GENOA CHARTER TOWNSHIP PLANNING COMMISSION PUBLIC HEARING APRIL 9, 2018 MONDAY 6:30 P.M.

Attention:	Kelly Van Marter, AICP
	Planning Director and Assistant Township Manager
Subject:	Family Farm and Home – Special Land Use and Site Plan Review #4
Location:	3685 East Grand River Avenue – north side of Grand River, west of S. Latson Road
Zoning:	RCD Regional Commercial District

Re: Family Farm and Home Site Plan Review #4

Attention:	Kelly Van Marter, AICP	
	Assistant Township Manager and Planning Director	
Subject:	Oak Pointe Country Club – Sketch Plan Review #1	
Location:	4500 Club Drive – terminus of Club Drive, north of Brighton Road	
Zoning:	MU-PUD Mixed Use Planned Unit Development

SHEET + NUMBER A5.00

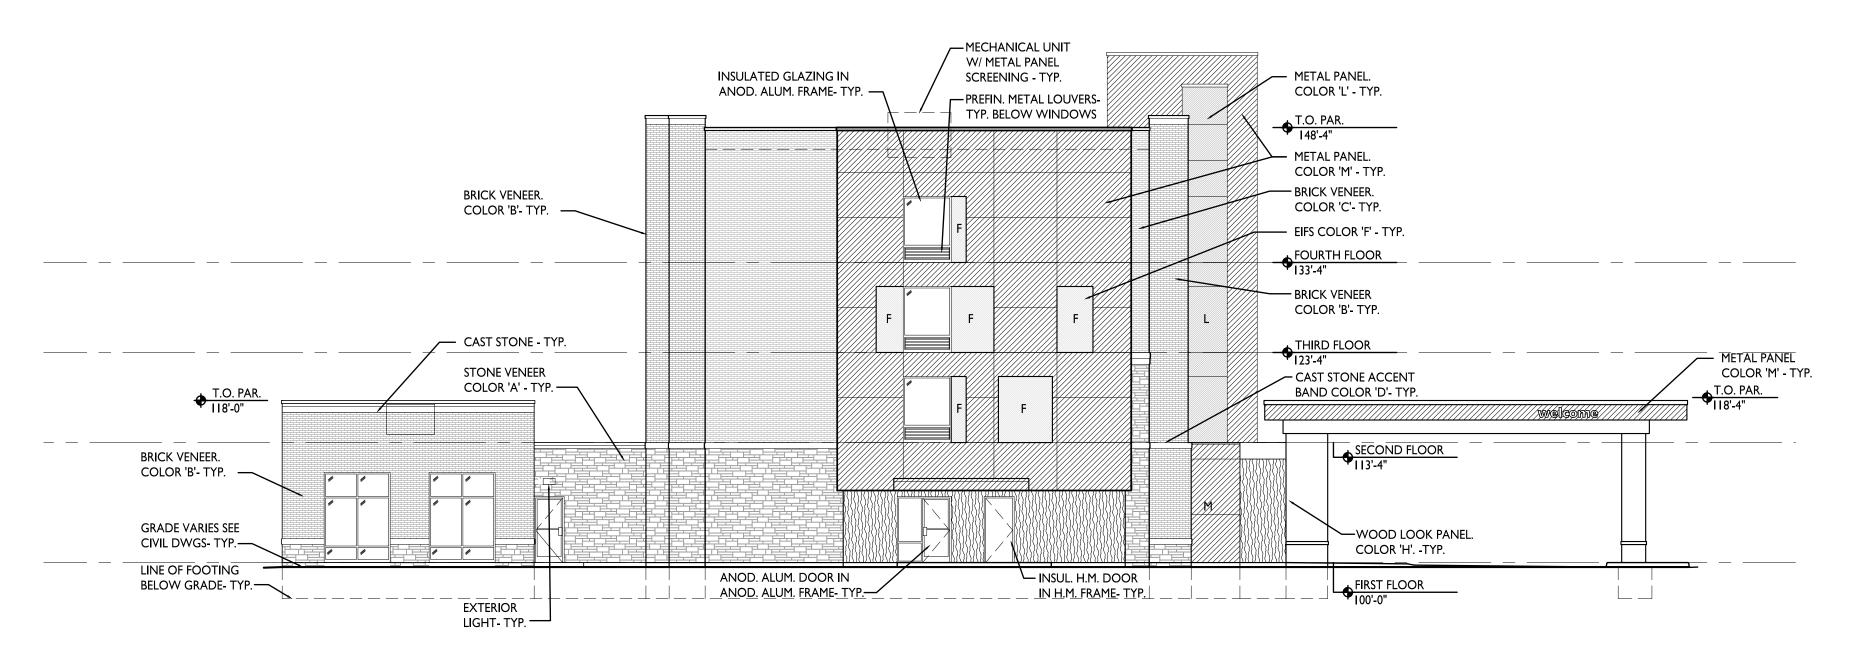
The proposed elevations, including colors and materials, are subject to review and approval by the Planning Commission. Amended building elevation drawings are found on Sheets A5.00 and A5.01.
